ADDENDUM

ADDENDUM NO.: #02

DATE: 02/08/2024

PROJECT: Woodhouse Ford Pro: Building Improvements

1 FOUNDATION PLAN - AREA B
 1/8" = 1'-0"

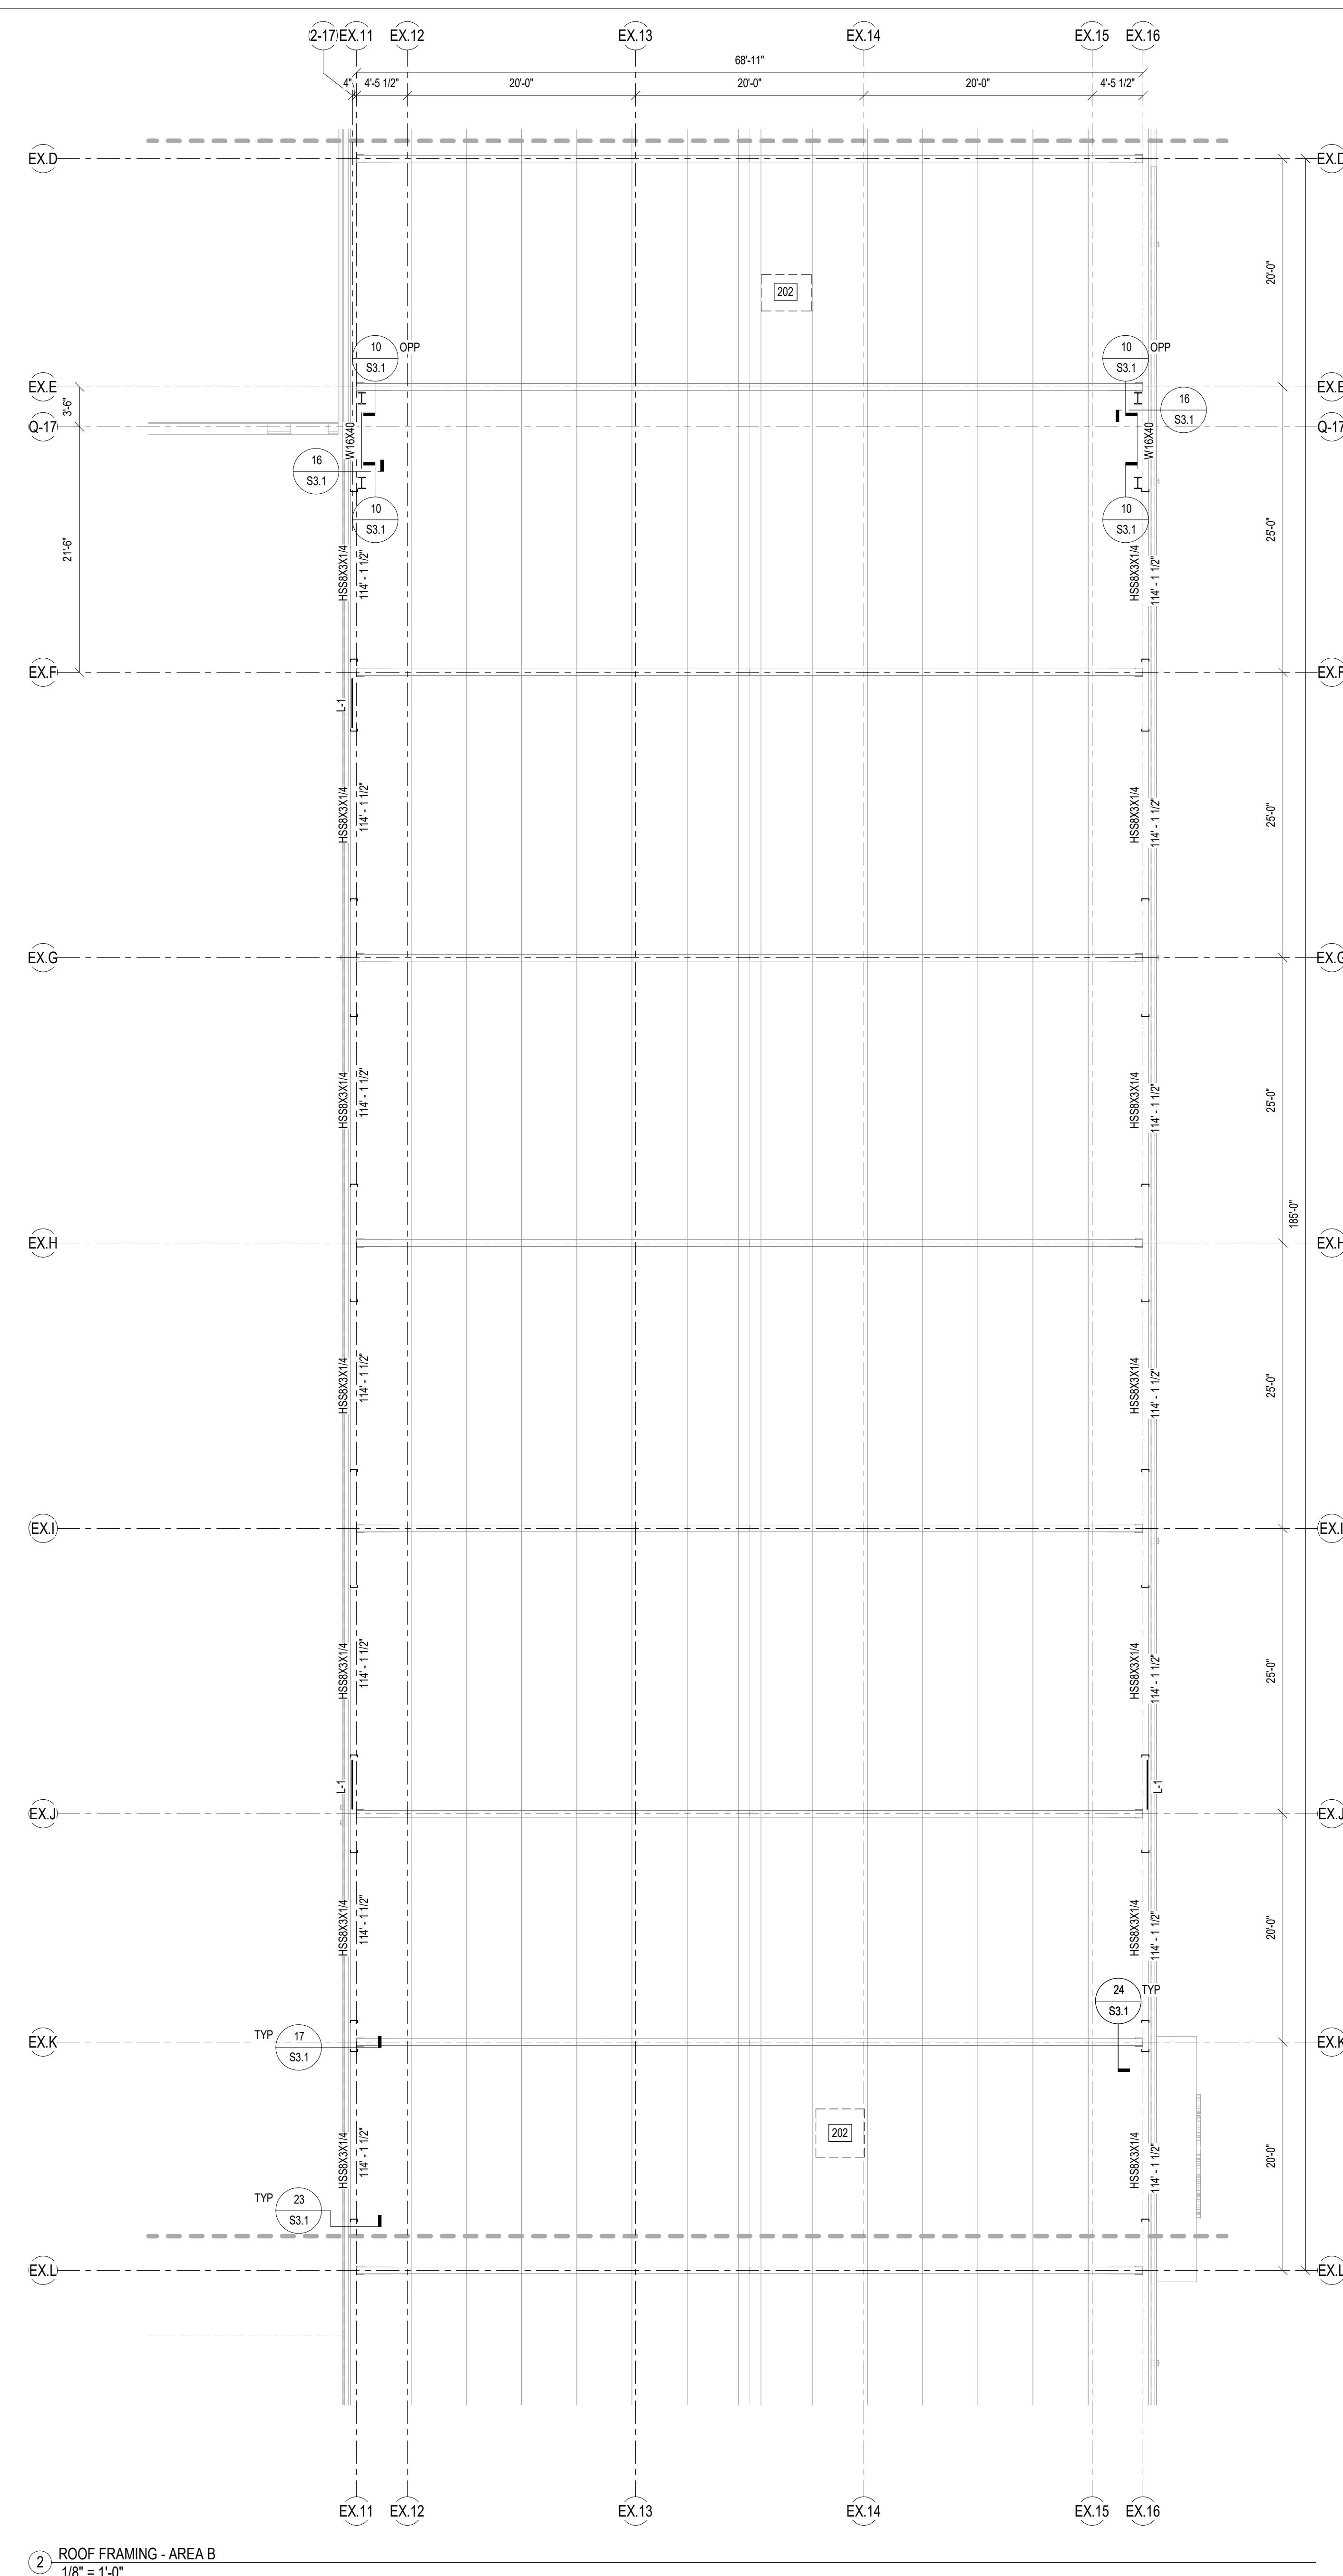
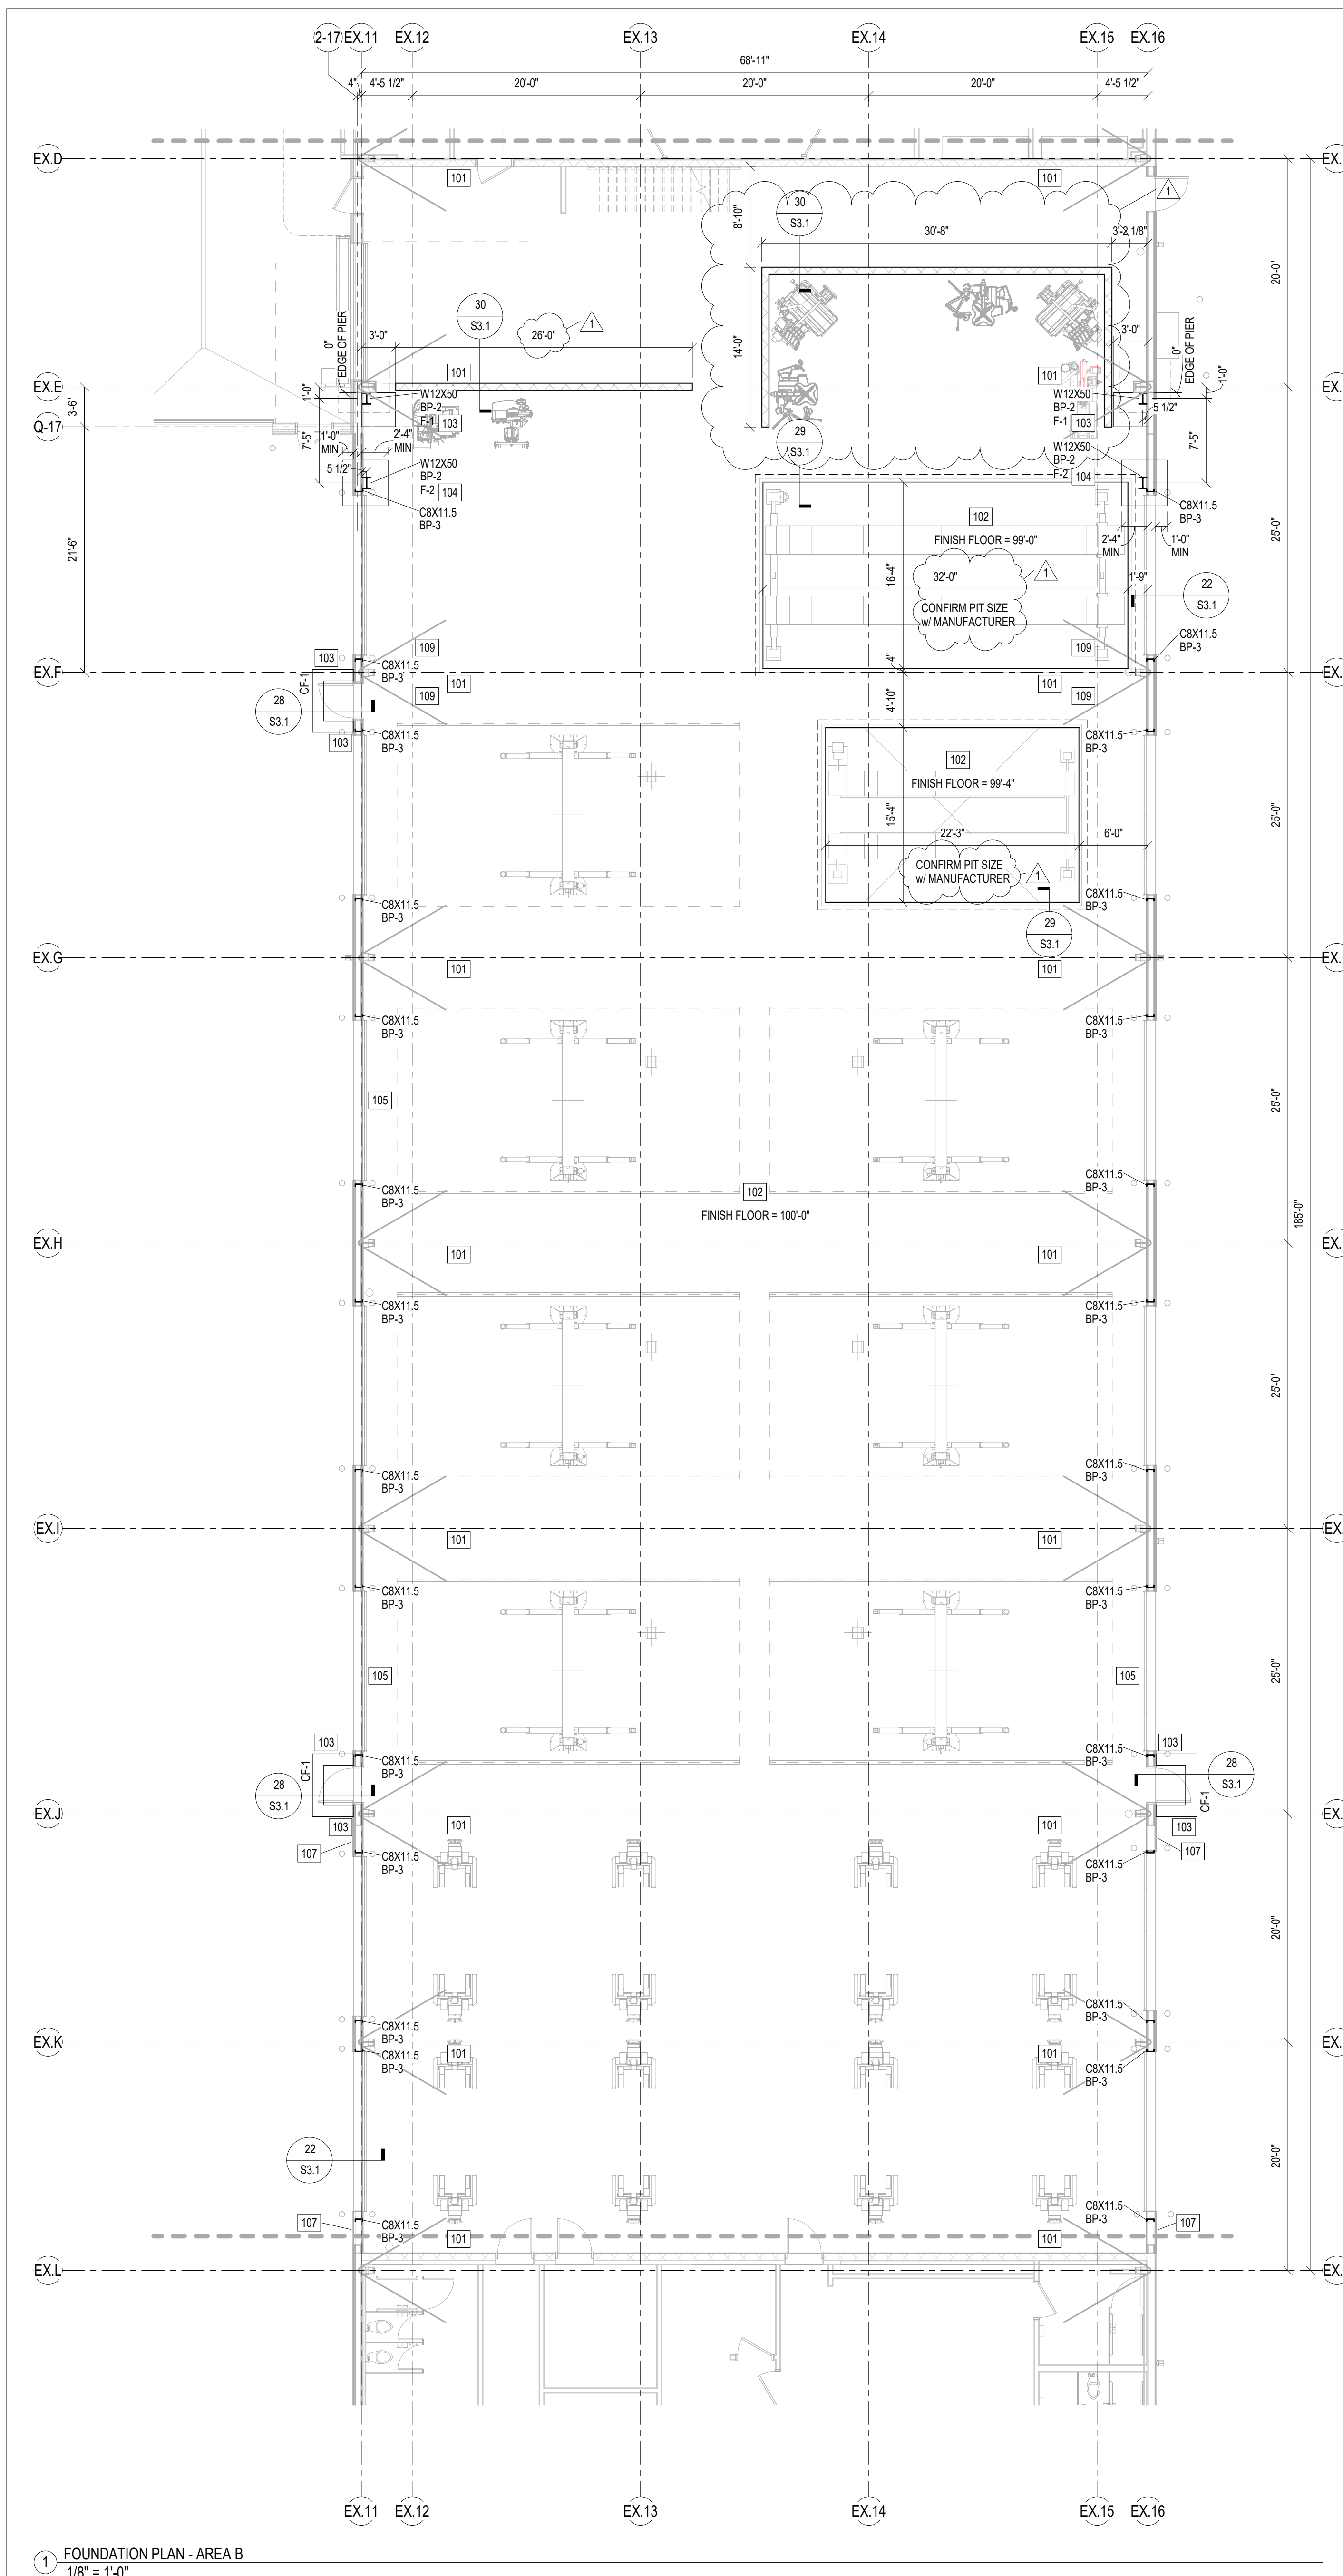
a. FOUNDATION – AREA B

- i. Update CMU wall length and add additional CMU wall. See attached revised drawing.
- ii. Update pit dimension and add note. See attached revised drawing.

1 FLOOR PLAN - HVAC - AREA A
 1/8" = 1'-0"

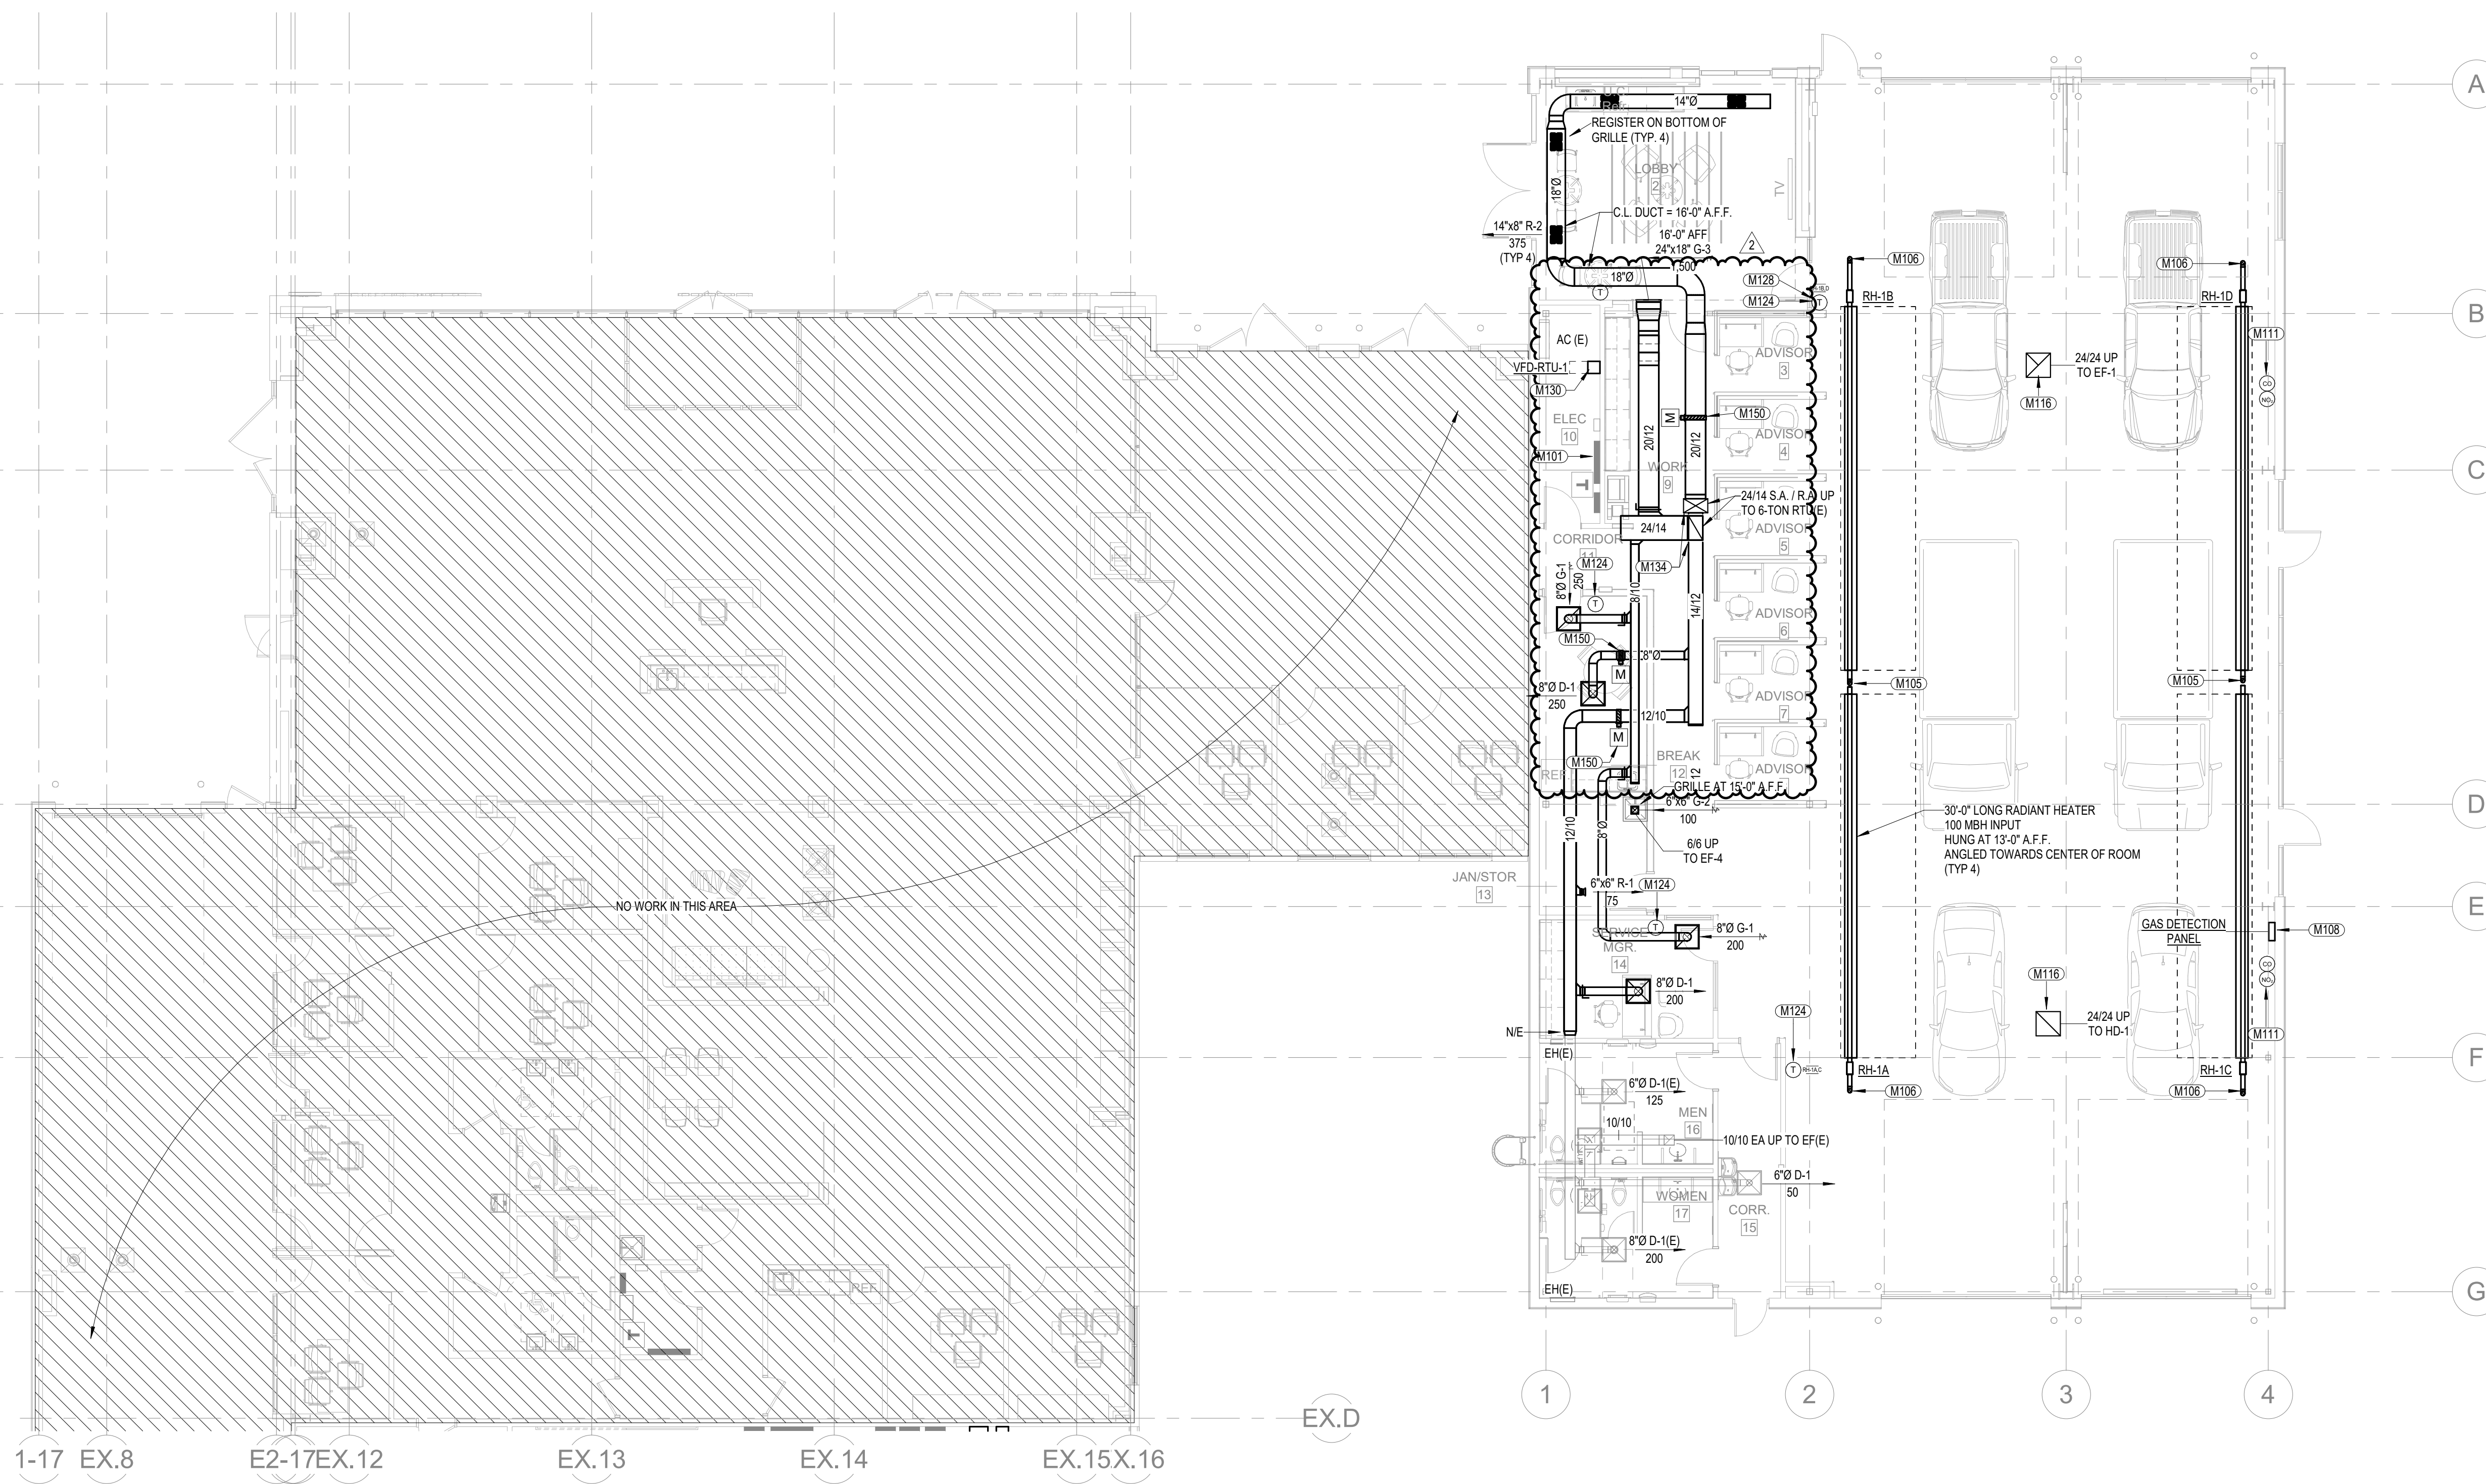
1. Sheet M1.1 – FLOOR PLAN – HVAC – AREA A
 - a. Revised notes for thermostats and vav dampers.
 - b. Add VFD for RTU-1(E) fan.
 - c. Removed bypass damper.
